**ADDENDUM NO. 1 FOR
SANTA FE ISD
WAREHOUSE AND ANNEX
PROJECT NO. 25-1037-42**

Attachment: Revised Proposal, 5 pages
Project Closeout Form, 1 page
Evaluation Criteria Form, 1 page
Sign-In Sheet, 4 pages
Roof Plans, GS1.00, GS1.01, GS2.01, GS2.02, R1.01, R1.02, and R2.01, 7 pages

SANTA FE ISD
2025 REPLACEMENTS
ANNEX & WAREHOUSE
4135 & 4137 WARPETH AVE.
SANTA FE, TX 77510

OVERALL ROOF
PLAN - WAREHOUSE

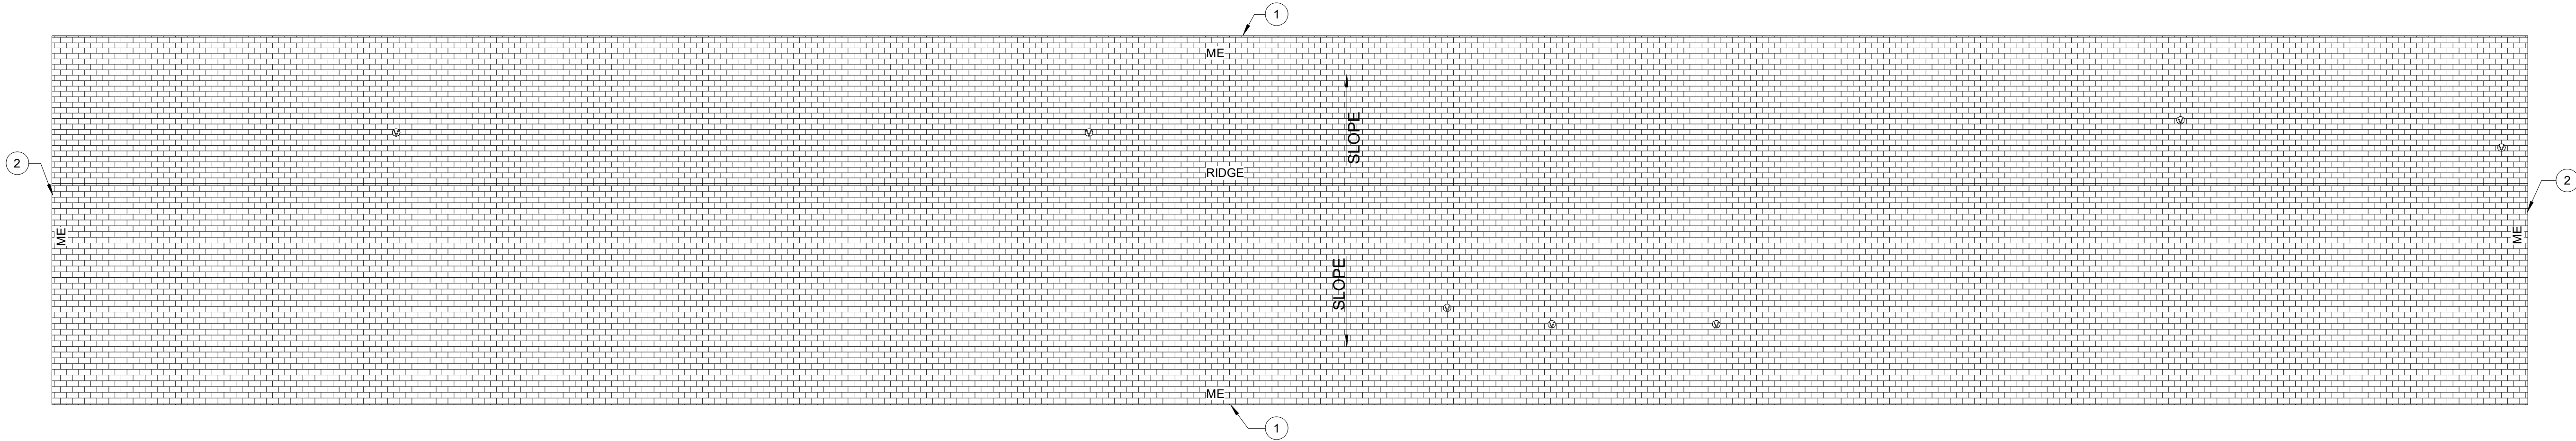
BASE PROPOSAL 1- SANTA FE MAINTENANCE WAREHOUSE:

- WORK SHALL INCLUDE ALL LABOR AND MATERIALS TO PROVIDE A NEW MULTI-PLY PVC KEE ROOF SYSTEM ON THE MAINTENANCE WAREHOUSE. ALL EXISTING ROOFING IS TO BE TAKEN DOWN TO THE EXISTING SLOPED TECTUM ROOF DECK. APPROXIMATELY TWENTY-FOUR (24), 2-INCH-THICK TECTUM ROOF PANELS WILL BE REQUIRED TO BE REMOVED AND REPLACED DUE TO STORM DAMAGE. ANY ADDITIONAL WILL BE REPLACED UTILIZING THE UNIT COST PROPOSALS.

ALTERNATE PROPOSAL 1- SANTA FE MAINTENANCE WAREHOUSE:

- CONTRACTOR TO REMOVE ALL EXISTING TECTUM ROOF DECK PANELS AND BULB-T'S FROM THE STRUCTURE TO INSTALL A NEW METAL ROOF DECK. NEW METAL DECK TO BE 1.5B18, (MIN 3-SPAN CONDITION) WITH MAXIMUM SPAN OF 6'-3". FASTEN DECK TO SUPPORT STRUCTURE WITH TEK-5 SCREWS AT THE BOTTOM OF EACH FLUTE (OVER SUPPORTING STRUCTURAL MEMBER). OVERLAP DECK EDGES AND FASTEN TO TOGETHER WI TEK-5 SCREWS @ 6" O.C.

OVERALL ROOF
PLAN - ANNEX

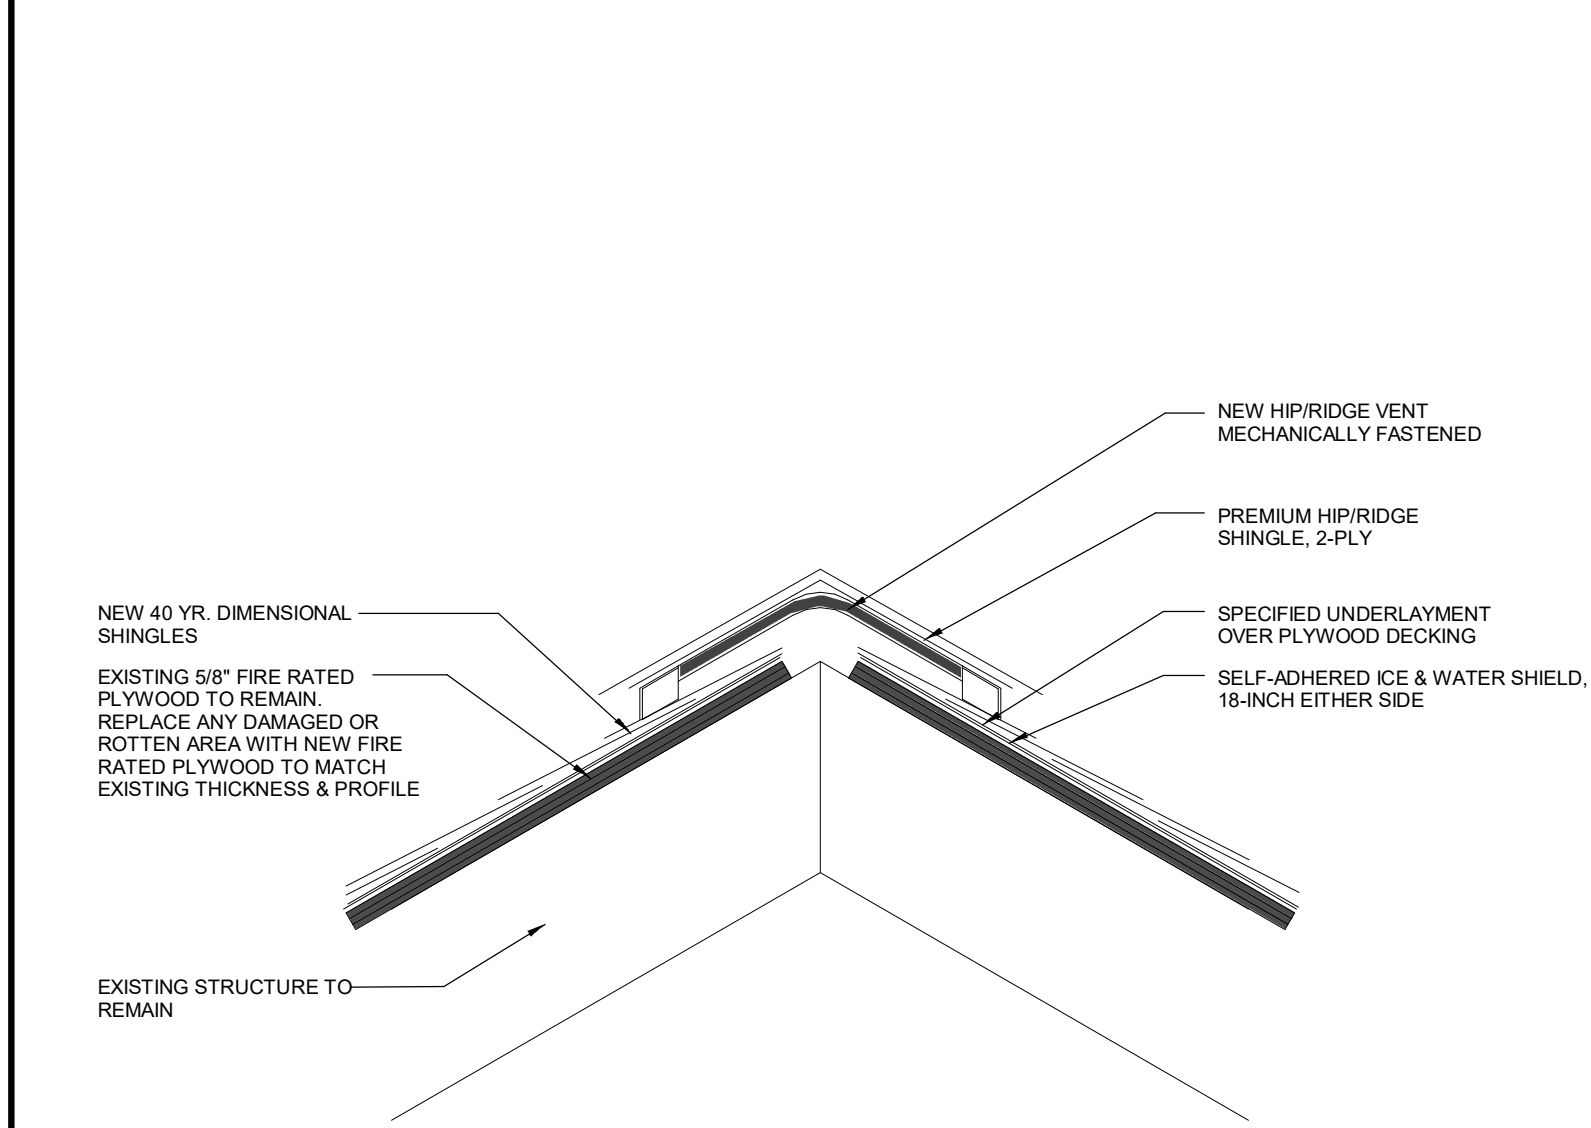
BASE PROPOSAL 2 – ANNEX BUILDING

- WORK SHALL INCLUDE ALL LABOR AND MATERIALS TO PROVIDE A NEW ARCHITECTURAL SHINGLE ROOF SYSTEM ON ROOF AREA A OF SANTA FE ISD ANNEX. ALL ROOF AREAS ARE TO BE TAKEN DOWN TO EXISTING PLYWOOD DECKING. CONTRACTOR TO INSPECT AND REPAIR ANY DETERIORATED PLYWOOD DECKING PRIOR TO INSTALLING A MECHANICALLY ATTACHED SYNTHETIC BASE SHEET.

- CONTRACTOR TO INSTALL A NEW ARCHITECTURAL SHINGLE TO MATCH EXISTING COLOR, FASTENED AT 6 NAILS PER SHINGLE FOR 'ENHANCED' APPLICATIONS OR AS REQUIRED TO MEET LOCAL WIND ZONE. TAMKO TITAN XT OR SIMILAR TO MEET WIND WARRANTY REQUIREMENTS
